CONNECTICUT
DEPARTMENT OF PUBLIC HEALTH
DPH

Technical Standards 2023 Updates

2023 Technical Standards

Section VI: Effluent Distribution, Pump Systems & Air Injection Processes {pg. 30}

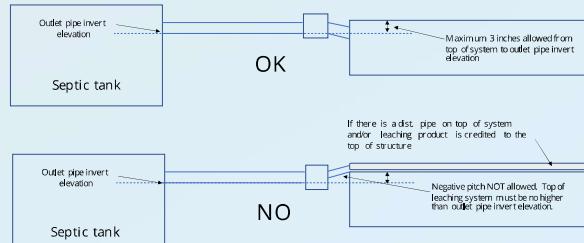
- The septic tank outlet invert shall be set no lower than 3 inches from the top of all leaching structures
- The effluent distribution piping between the septic tank and a leaching system shall not have negative pitch

Subsection C. Pump Systems:

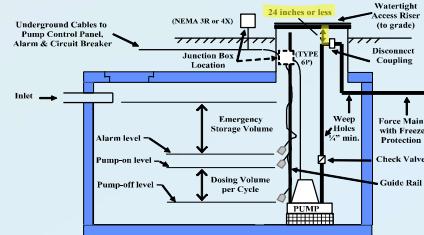
- Recommend detectable underground magnetic tracer/ warning tape be provided at least one foot above buried electric lines for the pump chamber
- A raw sewage pump force main should discharge to the septic tank via a 4-inch pipe connection to reduce velocity and solids disturbance. An inlet baffle is required for the tank at the force main connection.

Figure 13 - Minimum Separating Distances above
Ledge Rock and Maximum Groundwater

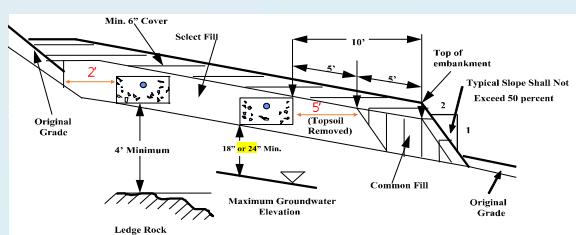
- On sloped lots only, select fill shall be reduced to 2 feet on the sides and up gradient of the leaching system
 - 5 feet extension down-gradient sloped lots (still required)
 - 2 feet for all other extensions (up-gradient and sides on sloped lots)
 - 5 feet fill extension around the perimeter shall remain for flat lots
